**OHIO RIVER BRIDGES  
SECTION 5 - EAST END BRIDGE  
VALUE ENGINEERING STUDY REPORT**

**Item Number 5-118.00**

**VALUE ENGINEERING STUDY  
for  
Kentucky Transportation Cabinet**

**Final Report**

## SKETCH OF ORIGINAL DESIGN

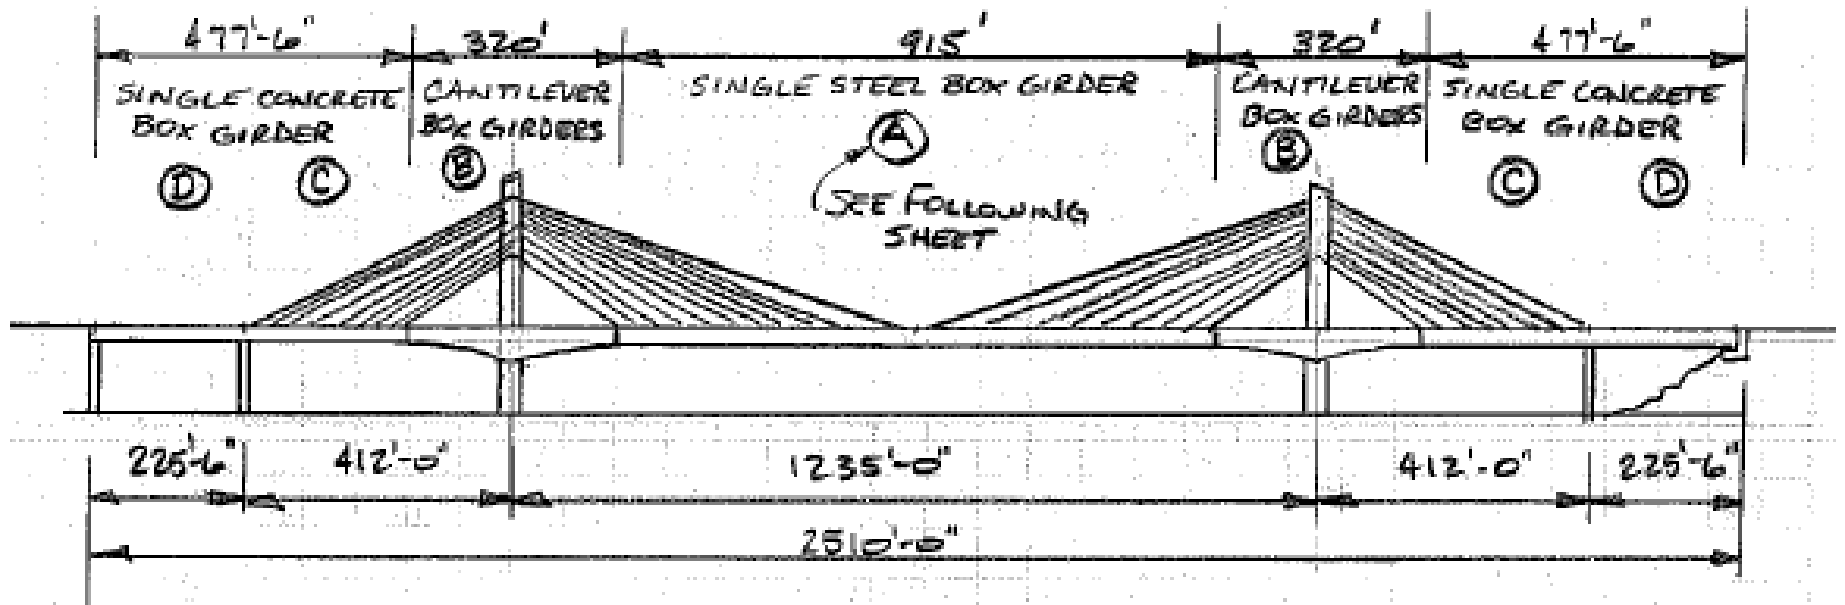
Reconfigure cable stayed bridge to a 3-span system in lieu of a 5-span system; shorten main span and increase side spans to balance system (550'-1100'-550' in lieu of 225.5'-412'-1235'-412'-225.5').

Decrease the main span length to 1100' by placing the towers up tight to the navigation channel. Tower foundations should be submerged to 15' below normal pool as discussed in Design Comment 20 which also allows main span length to be reduced. Increase the side span lengths from 412' to 550' in order to properly balance the 1100' main span without resorting to a steel box girder mains span section.

Replace the 915' long composite steel box girder system with the concrete box girder system utilized in the side spans. Since the main span and side span lengths are now balanced, the use of a light weight and more expensive steel box girder system is unnecessary.

Approach span on Kentucky and Indiana bank will be reduced from 225'-6" to 155'-0" due to increase in total length of cable stayed bridge. The Kentucky approach span should be consistent and continuous with the structural system utilized in the Section 4 Kentucky approach bridge, probably steel plate girders. Also use steel plate girders for the Indiana approach span.

**SKETCH OF ORIGINAL DESIGN**

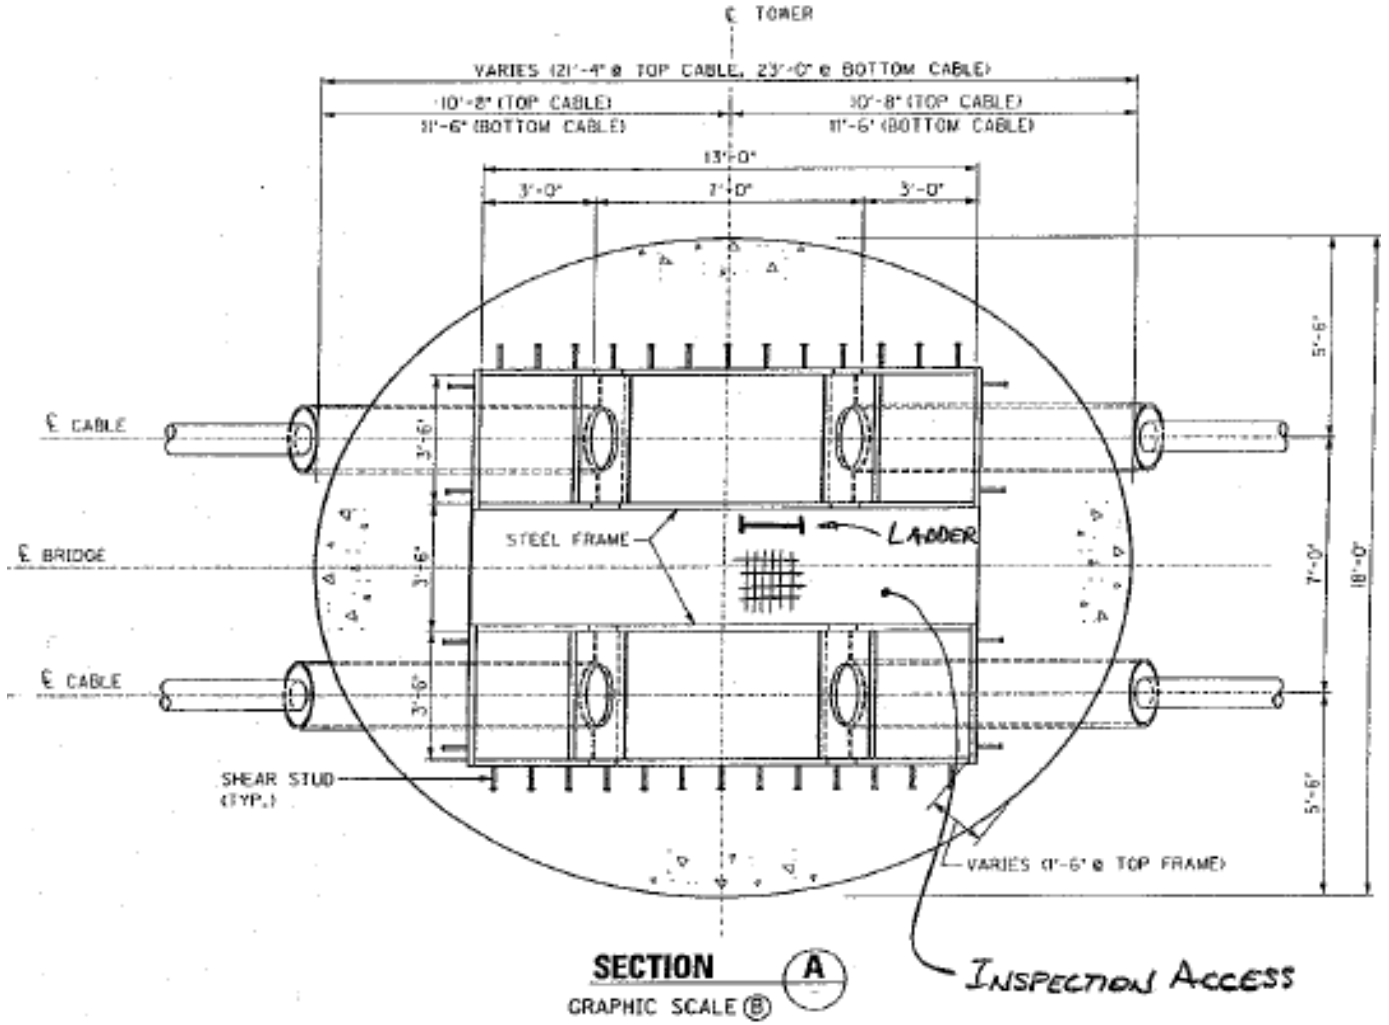
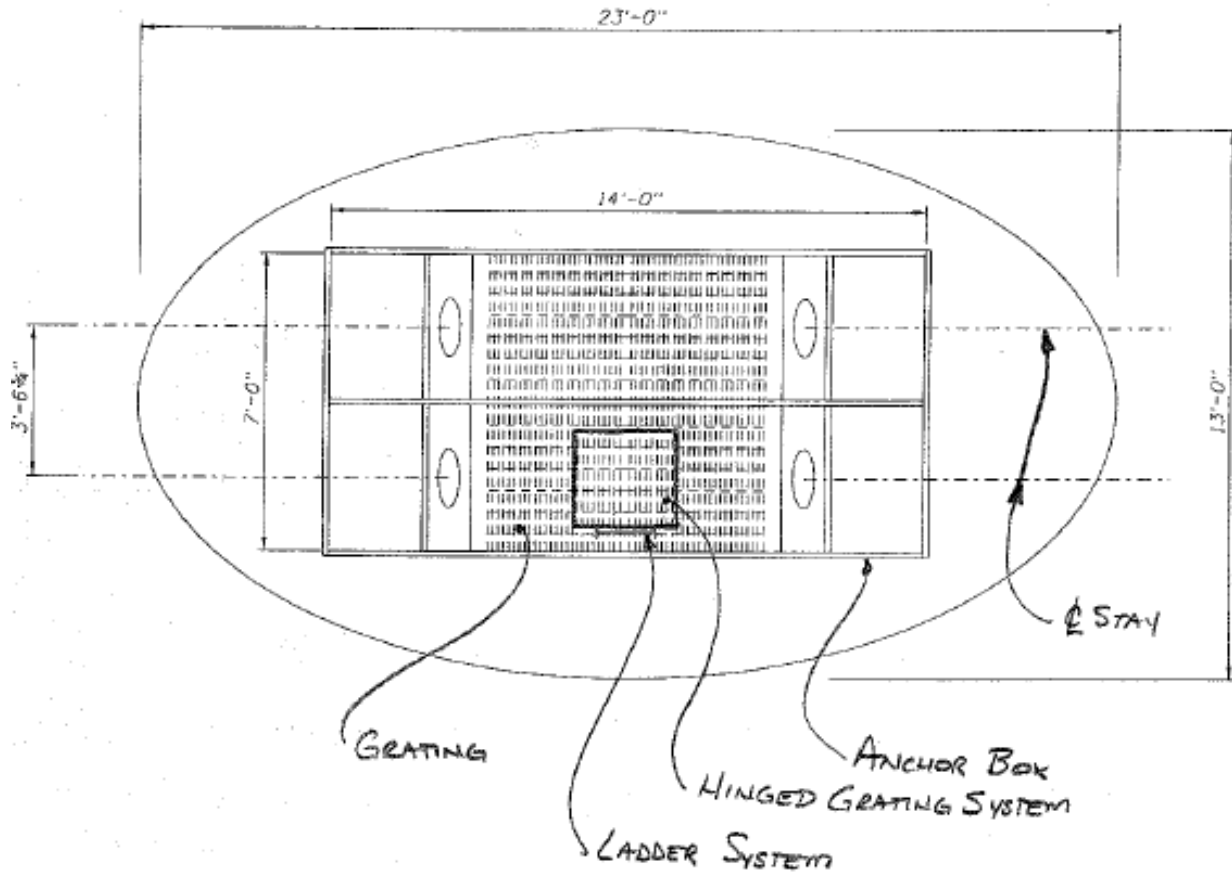
Reduce the tower width from 18'-0" to 13'-0" by placing the two stay cable steel anchorage boxes side by side. In the Preliminary Plans the stay cable anchorage boxes are separated by 3'-6" to provide for inspection access within this gap. This gap can be eliminated and the two anchor boxes set side-by-side and inspection access provided within one of the anchorage boxes. The entire bridge deck width can be reduced by 5'-0" due to a narrower tower.
